# Addendum 02

**PROJECT:** Riverside Local School District  
Central Office and Health Clinic Addition  
2096 County Road 24 S  
De Graff, Ohio 43318

**PROJECT #:** 22071-00

DOOR HARDWARE MATERIAL LIST

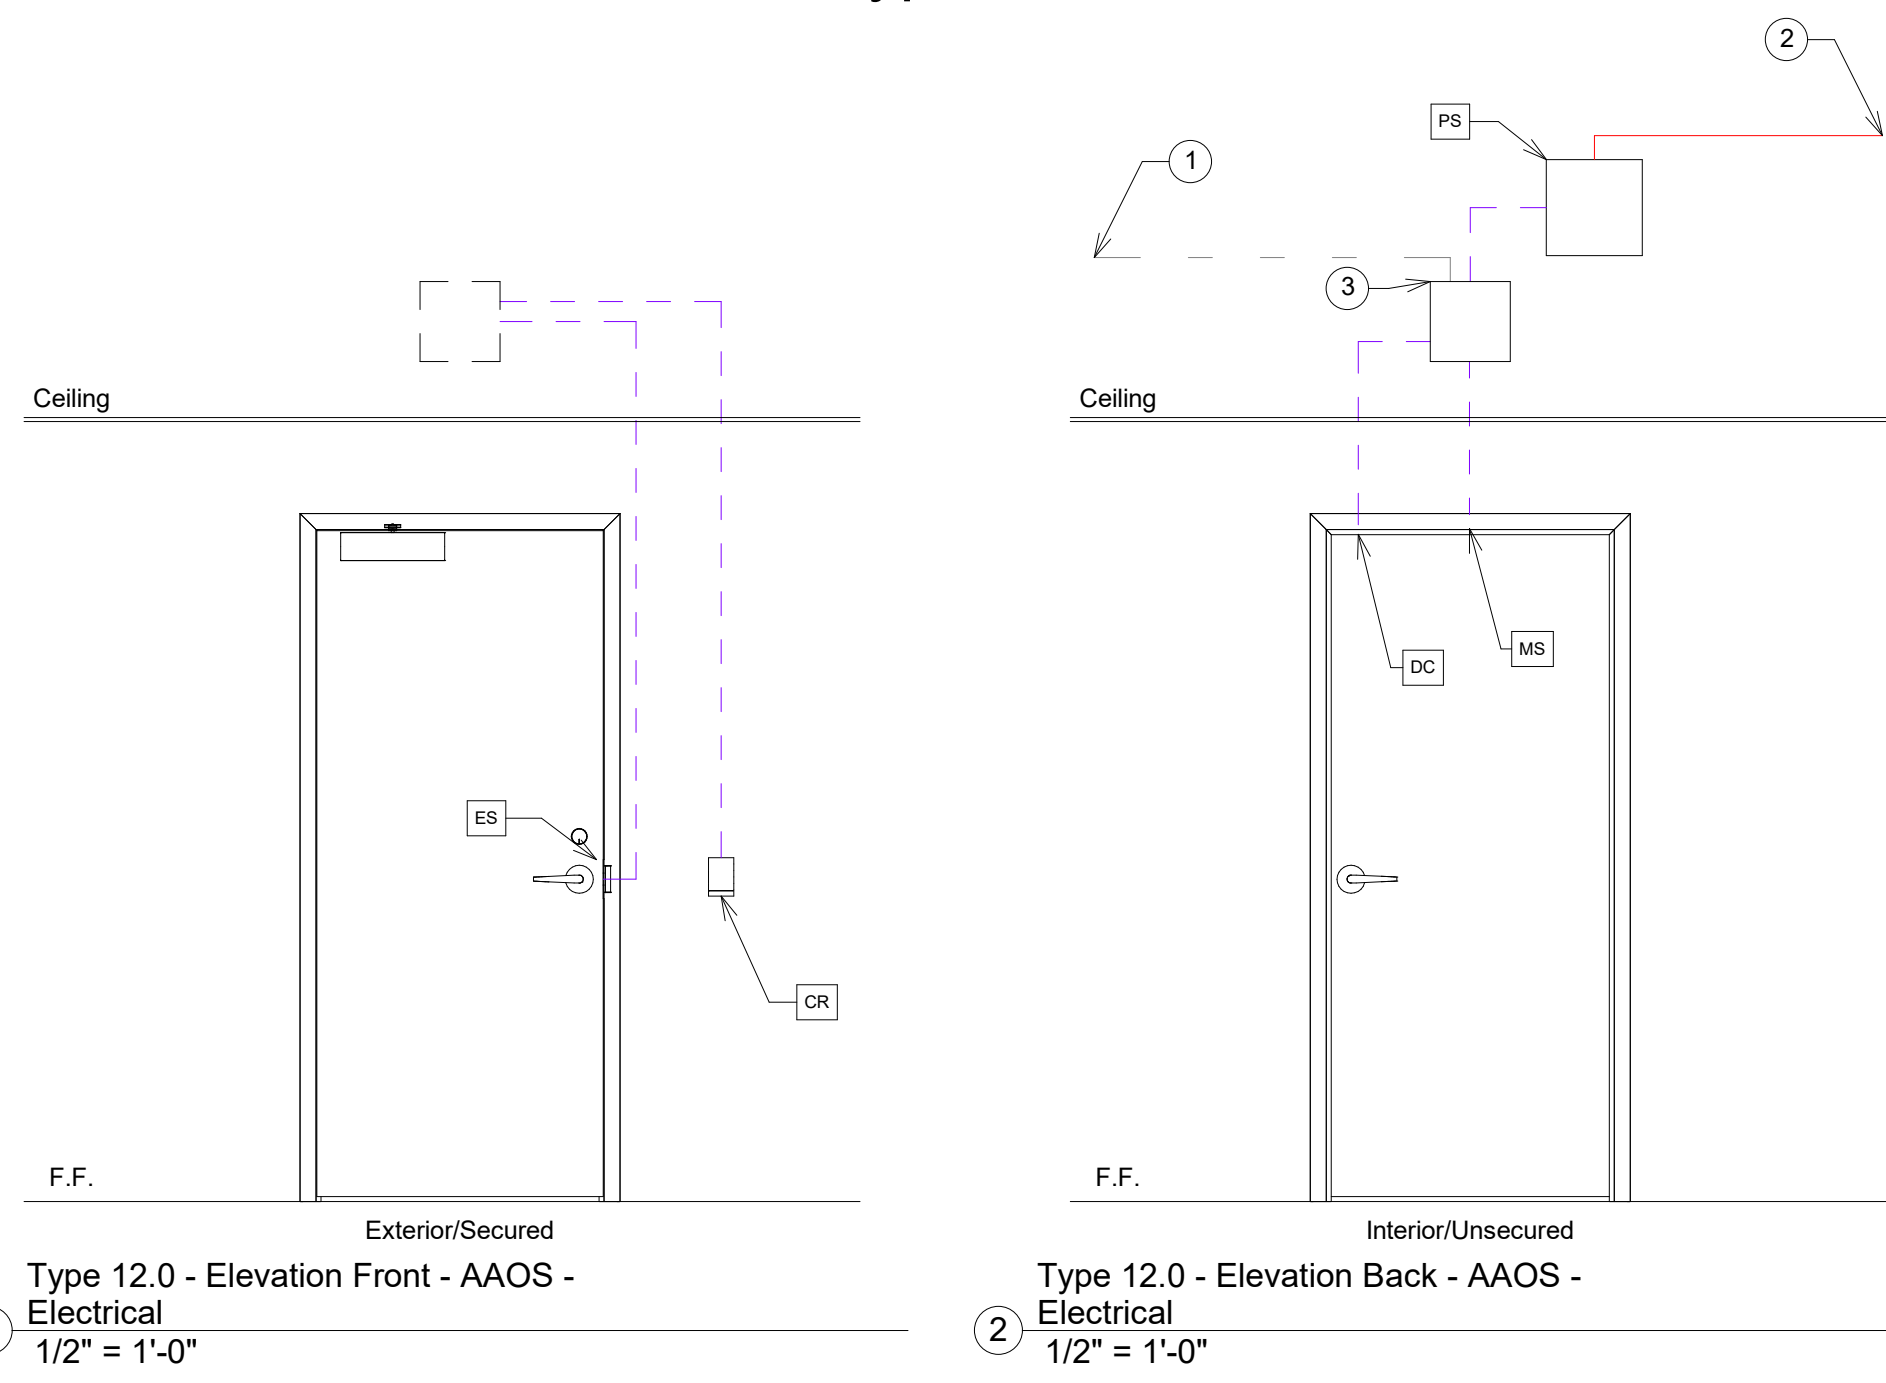
1. Add drawing Sheet E1.3 EAC Security Elevations in its entirety. Reference sheet attached.
2. Add drawing Sheet E1.4 EAC Security Elevations in its entirety. Reference sheet attached.
